ENG-SP20008-R2-GEC-redlines Markup Summary

Subject: SW - Comment
Page Index: 2
Date: 4/5/2021 11:54:21 AM
Author: GReese
Color: ■
Layer:
Space:
Page Label: [2] 2 GR_01 - GR01

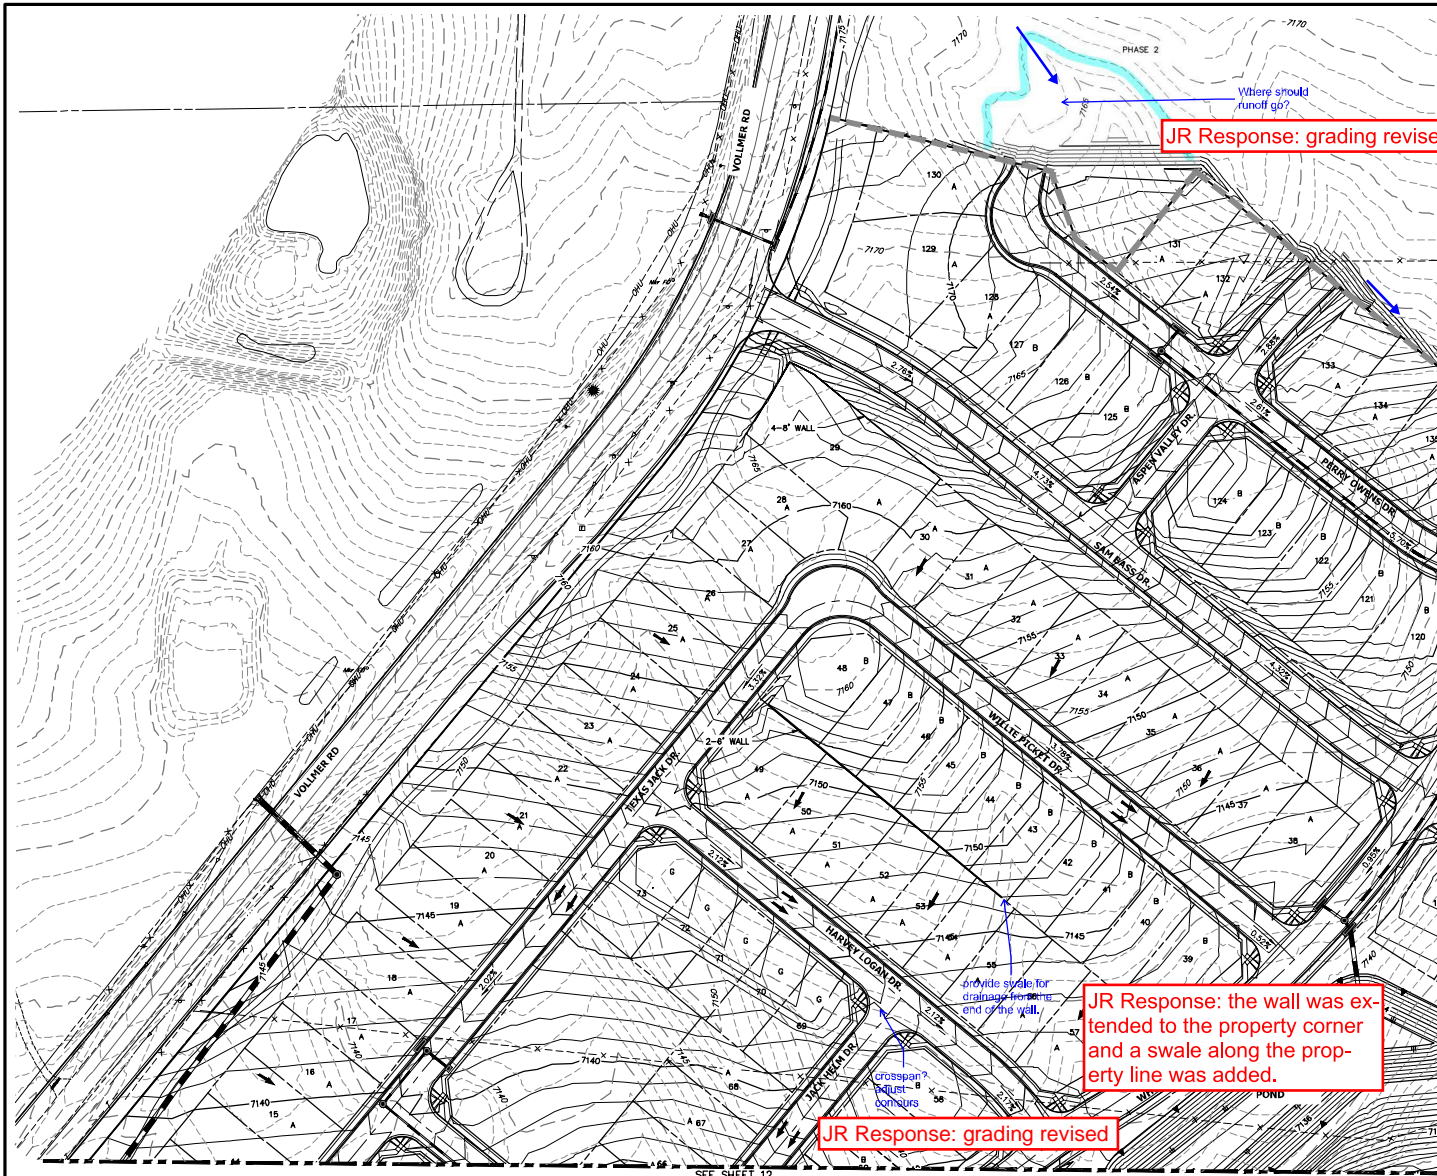
Show detail for CWA on last sheet.

Show check dams (rock socks, straw bales, etc) in rough cut street drainage (typical all sheets). And add detail of selected BMP to last sheet. Also see MHFD Detail EC-9 and add that to last sheet.

JR Response:
Addressed

JR Response:
Addressed.

Subject: SW - Comment
Page Index: 7
Date: 4/5/2021 12:04:39 PM
Author: GReese
Color: ■
Layer:
Space:
Page Label: [7] 7 GR_02 SRR and BGP - GESC (4)

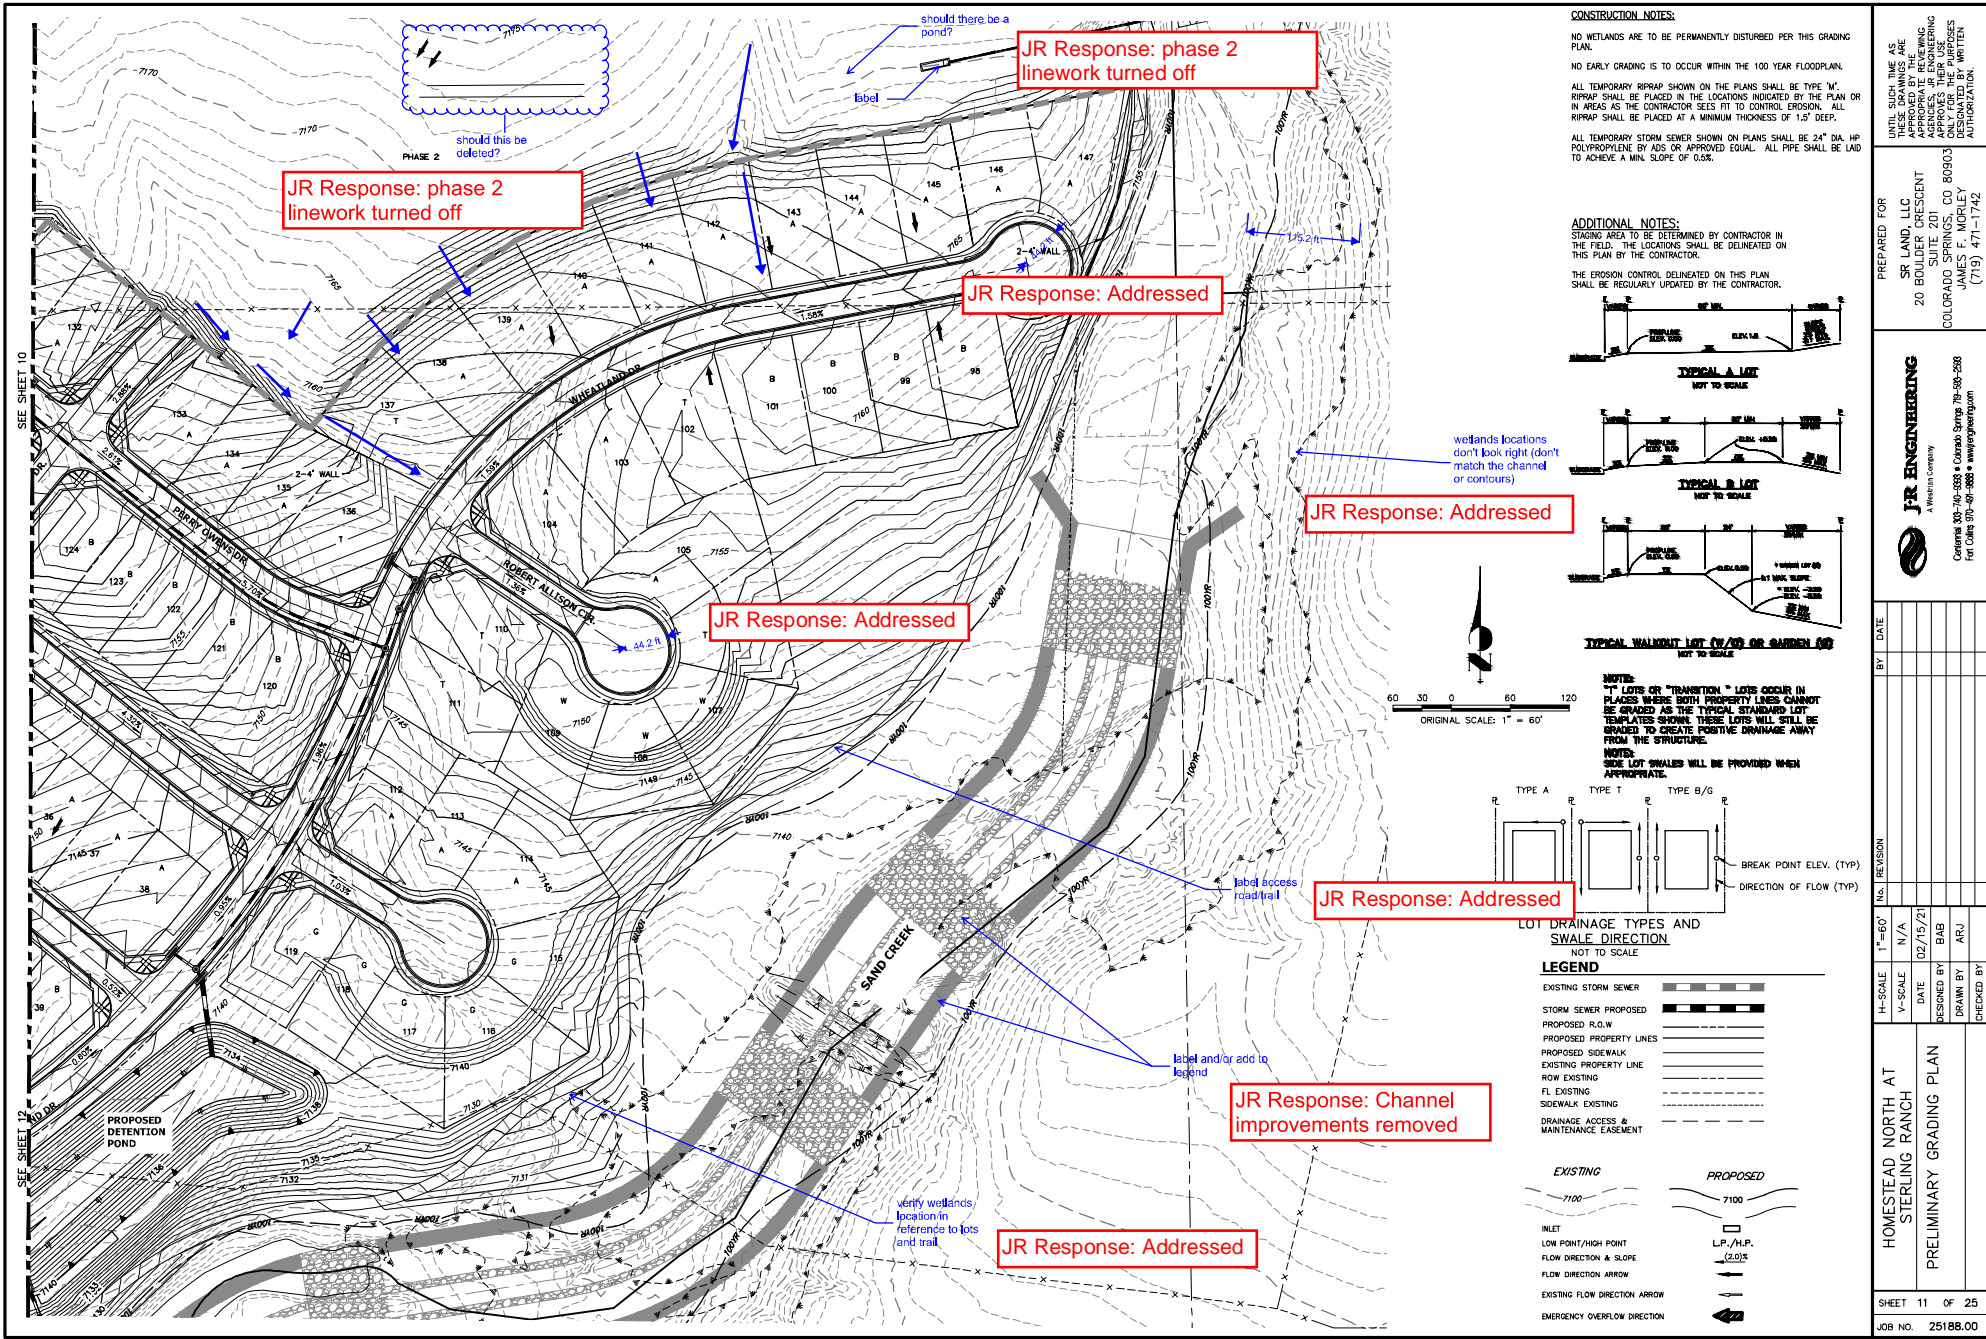
unimproved area between spillway and creek bank needs riprap as well.

JR Response:
Addressed.
10'x 90' riprap
pad added
